Dillon Consulting

03-1221-310

The current revised document follows a series of questions prepared by Government of Nunavut officials. These questions were transmitted to Golder on September 12, 2003. The following list identifies where to find, in the current revised letter, additional information on each specific question:

REHABILITATION OF THE SEWAGE LAGOON
POND INLET

MECHANISMS THAT COULD CAUSE UPWARD
FAILURE OF THE GCL

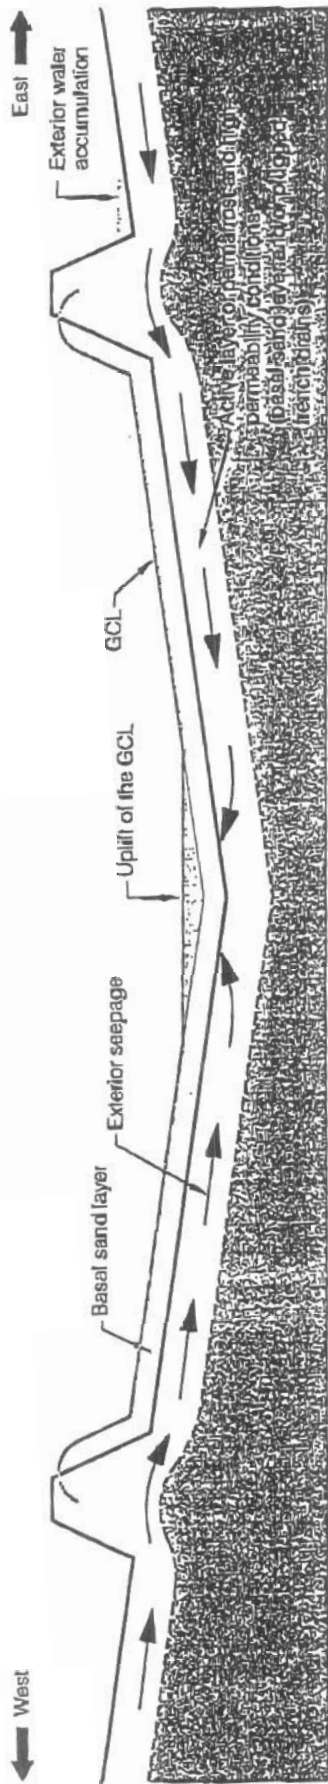
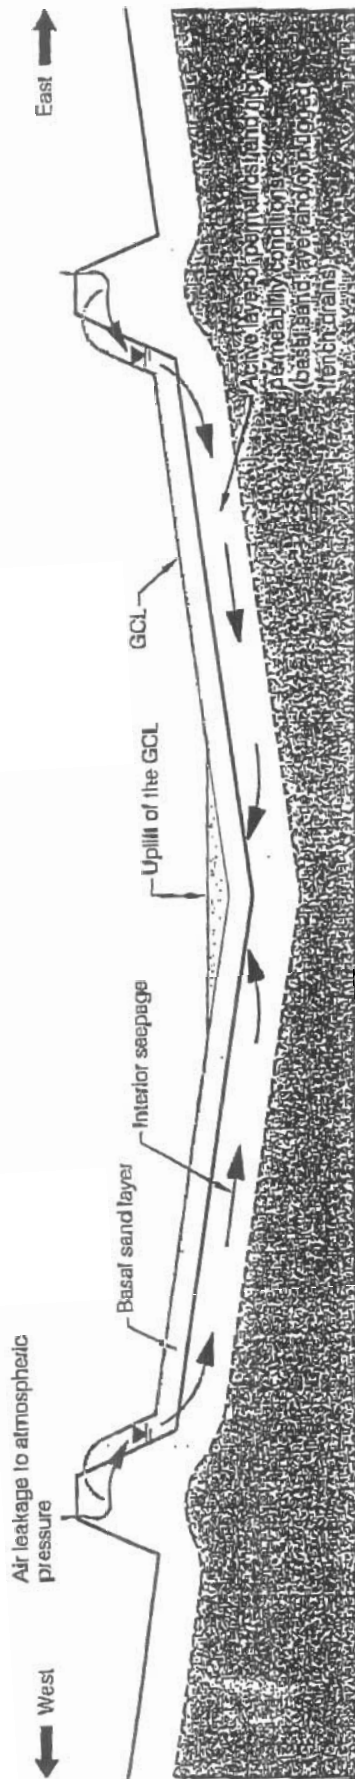
- A risk of causing the uplift of the GCL exists every summer if the saturated drains act as preferential channels and transmit high pore pressure conditions to the centre of the pond. Such high pore pressure conditions could either result from the perimeter of the base or from the external site conditions. Such a risk also exists from the presence of the sand basal layer which is part of the current design. These phenomena are described on Figure 2.

Altogether, it is believed the French drains should be plugged prior to the deployment of the membrane in 2004, and a minimum water pressure should be maintained at all time afterwards to avoid uplifting of the GCL as a result of pore pressure transmission through the basal sand layer and/or French drains.

- Plug the outlet of the French drains to minimize the risk of creating a downward gradient that could cause failure of the GCL over the drains;
- Provide permanent minimum weight on to the GCL to minimize the risk of uplifting the GCL; and
- Minimize the risk of having external water reach the base of the basin by diverting external runoff away from the site.

FIGURE 3: Schematic of the Decision Making Process

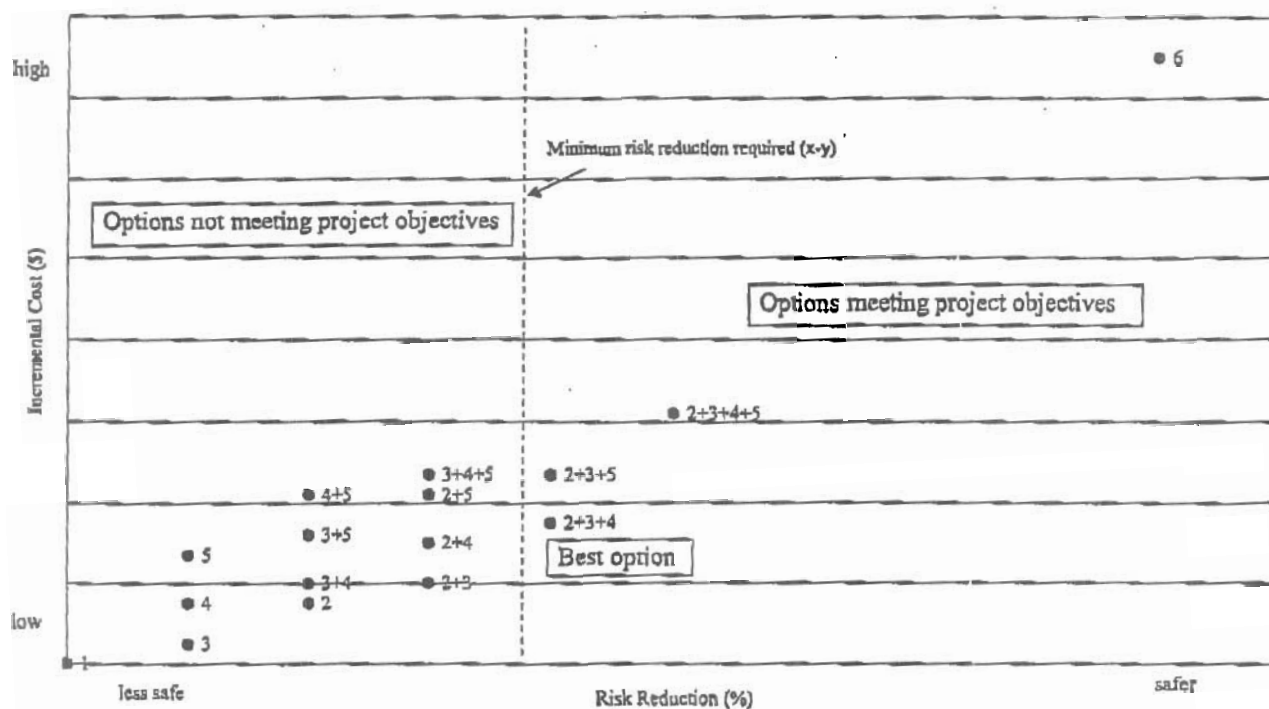
No valuable discussion can be put forth at this point in time regarding the cost effectiveness of risk reduction alternatives, including relocation of the pond to a different site. Such discussion could only follow the completion of a risk assessment and the definition of the costs of the various corrective scenarios. A schematic of the decision making process is presented in Figure 3.

In this example, combining options 2, 3 and 4 provides a lower additional cost while achieving the minimum risk reduction required for this project.
